# ADDENDUM NO. 3

**January 18, 2024**

**Jeffersonville High School Aquatic Center – New Facility**  
**2315 Allison Ln**  
**Jeffersonville, IN 47130**

This Addendum consists of Pages ADD 3-1 through ADD 3-3 and attached Fanning Howey Associates Addendum No. 3, dated January 18, 2024, consisting of 5 pages, New Project Manual Section 08 11 13 – Hollow Metal Doors and Frames, Revised Project Manual Sections 08 71 00 – Door Hardware and 28 31 11 – Digital, Addressable Fire-Alarm System, and Addendum No. 3 Drawings: C-105, S1.01, S1.03, S1.04, S5.03, S5.05, A1.01, A1.31, A2.02, A3.01, A5.03, A6.01, A6S.01, A7.01, A7.02, A7.21, A7.22, A7.41, A7S.01, A8.01, A8.02, A8.21, A8.22, A8.30, A8.31, A8.32, A8.33, A8.34, A8.30, A8.41, A8S.01, PL0.0, PL1.0, PL1.1, PL2.0, PL4.0, PL5.0, PL10.0, PL11.0, M1.01, M1.11, M1.17, M2.01, E1.02, E4.01, E5.01, E5.02, E5.03, E5.04, E5.05, E5.06, E6.01, E6.04, TA6.00, T1.01, T1.11, and T1.21.

SWIMMING POOLS  
COMPOSITE PIPING PLANS

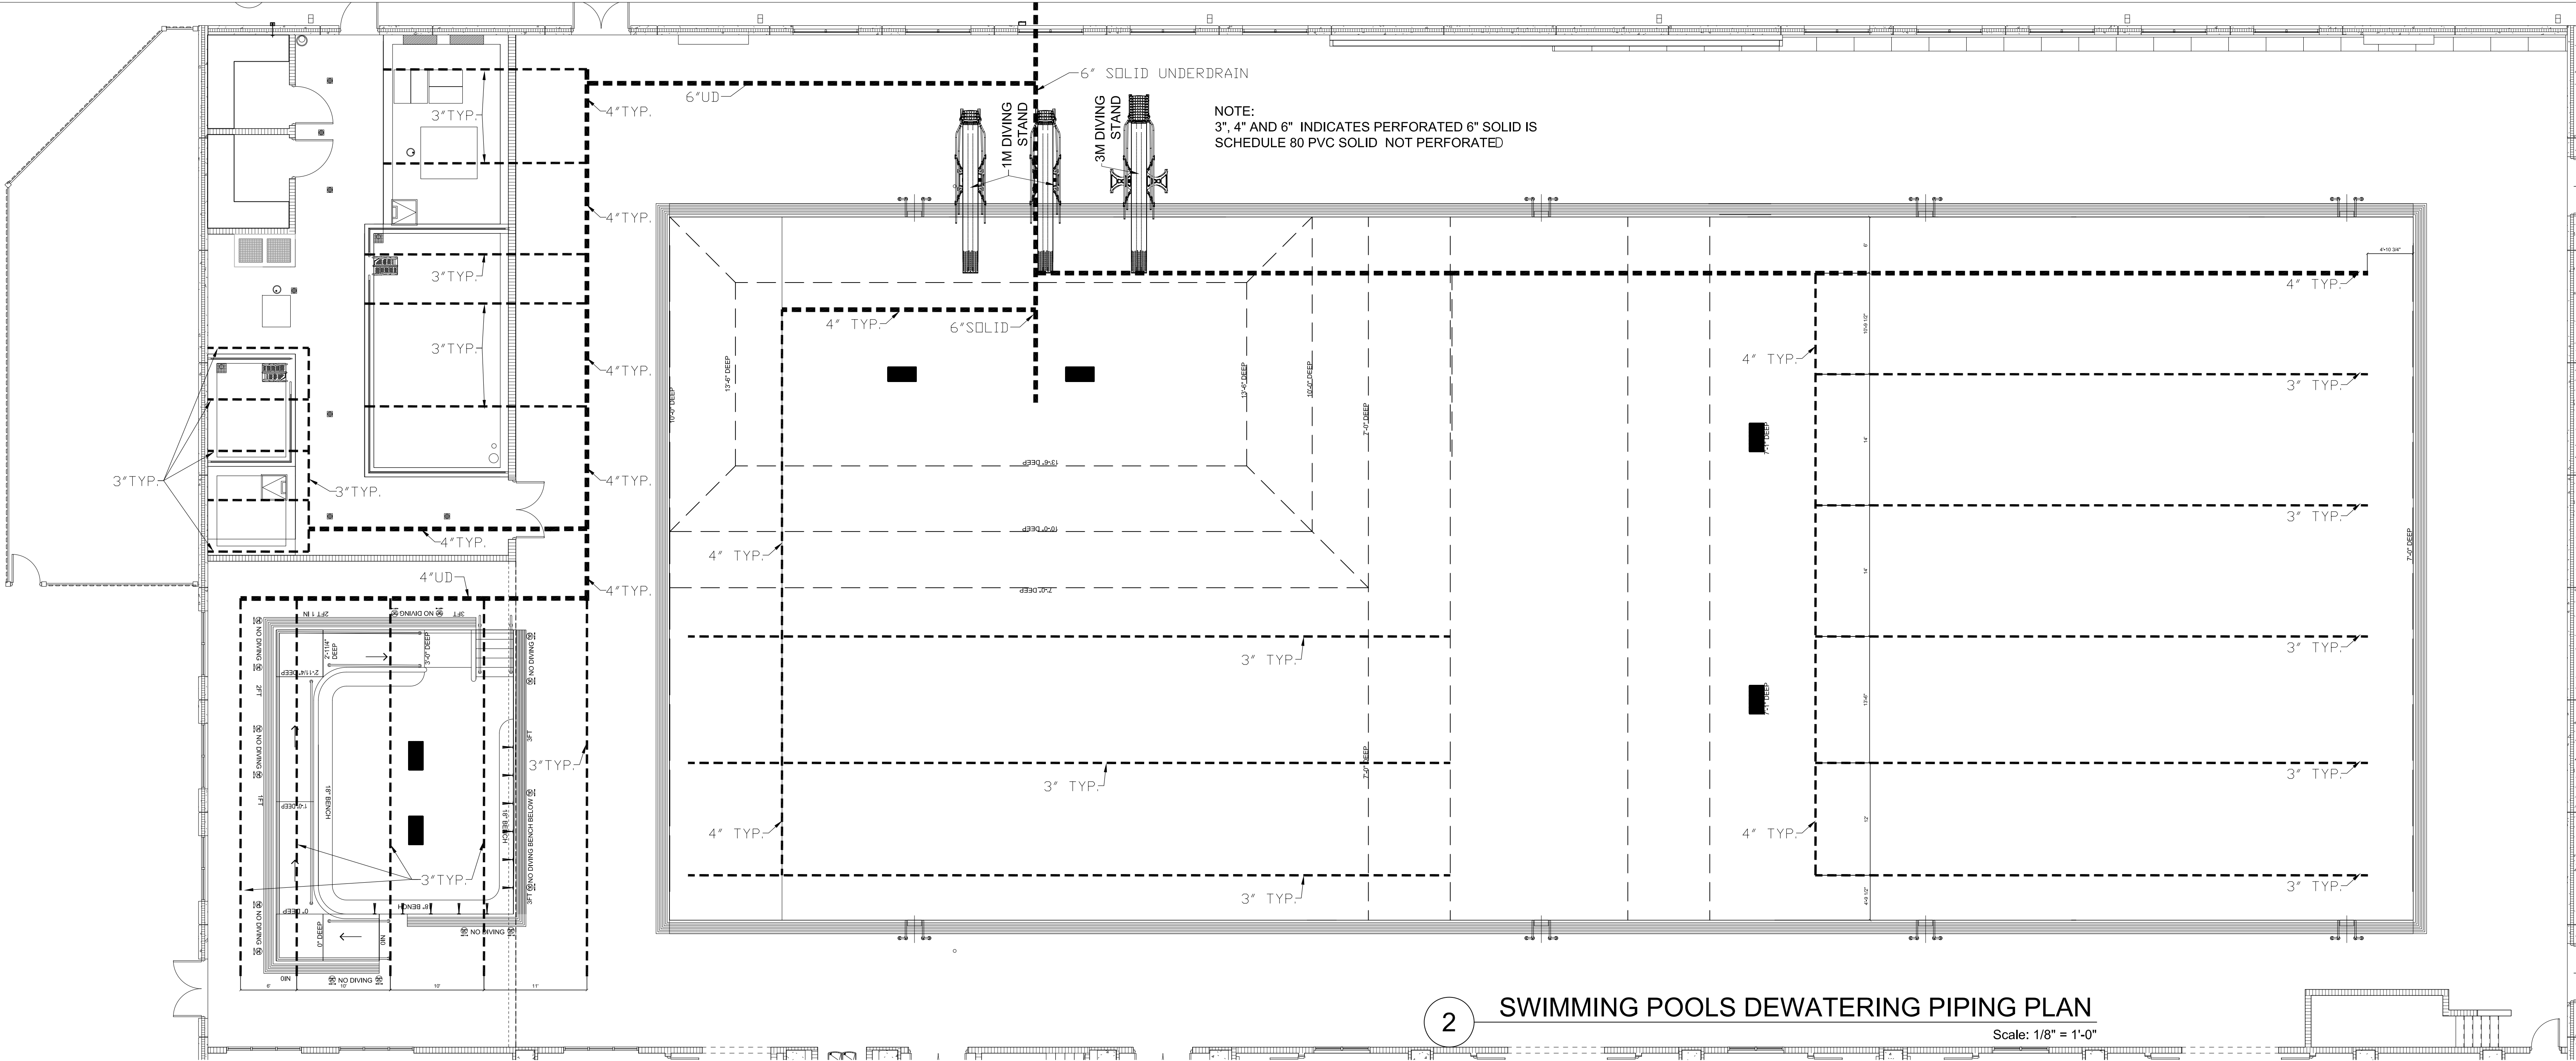
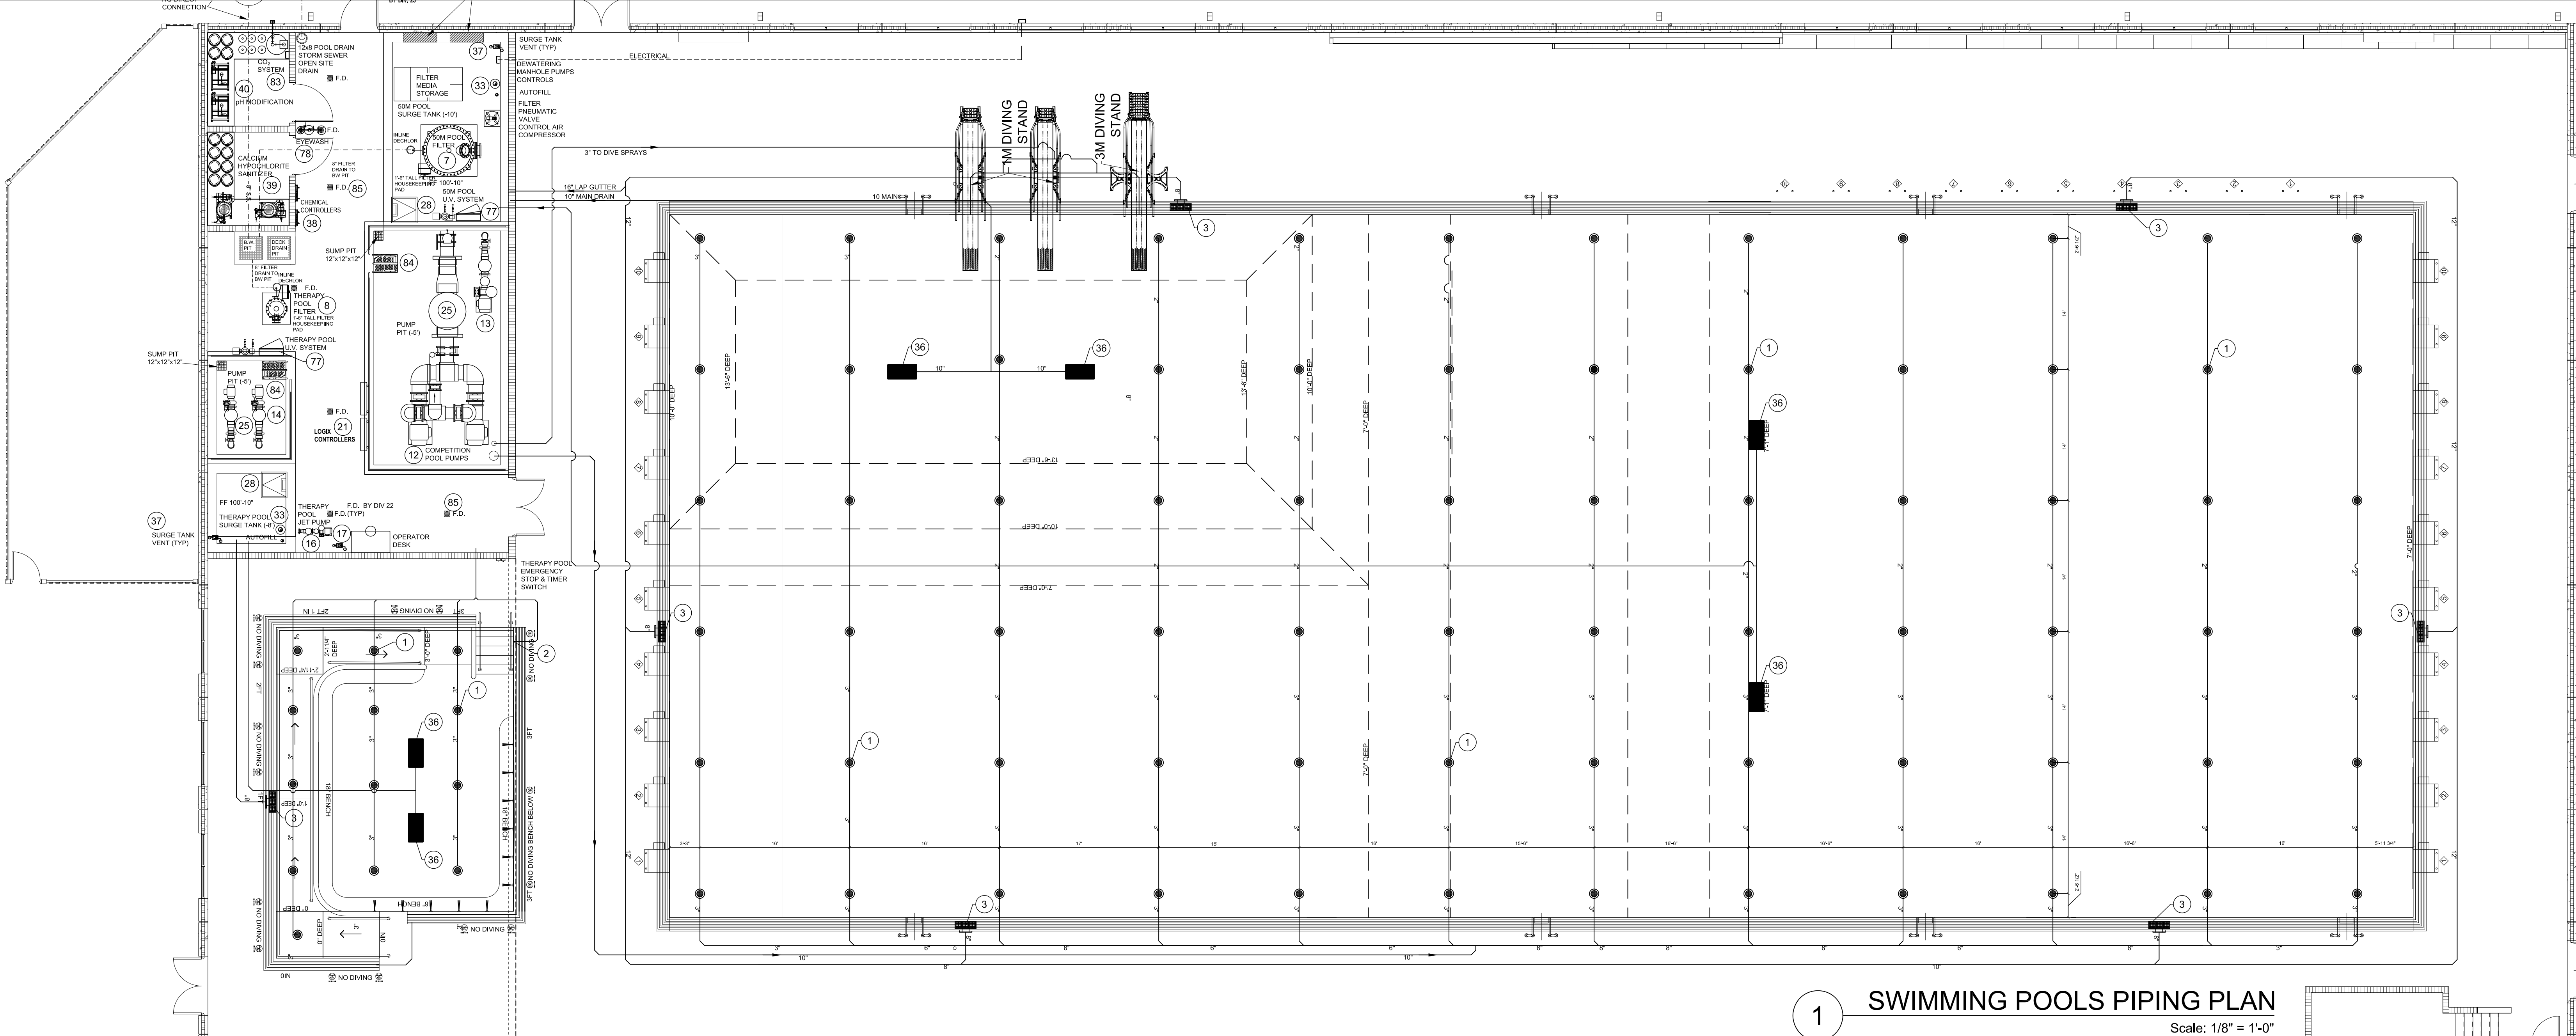
19. Provide Aluminum bleacher seating.  
20. Provide all 3” & 4” underdrainage outside of the Competition Pool area including the 4” to 6” Tee connection as referenced on Sheet PL1.0. Bid Category 10 to provide all remaining underdrainage from this point up to 5 feet outside the building exterior foundation walls.  
21. Provide all work required to complete Pump Pits, Surge Tanks & Balance Tanks. Include excavation, ladder rungs, access door, and waterproofing. Reference Specification Section 13 15 00 for additional requirements to complete this work.
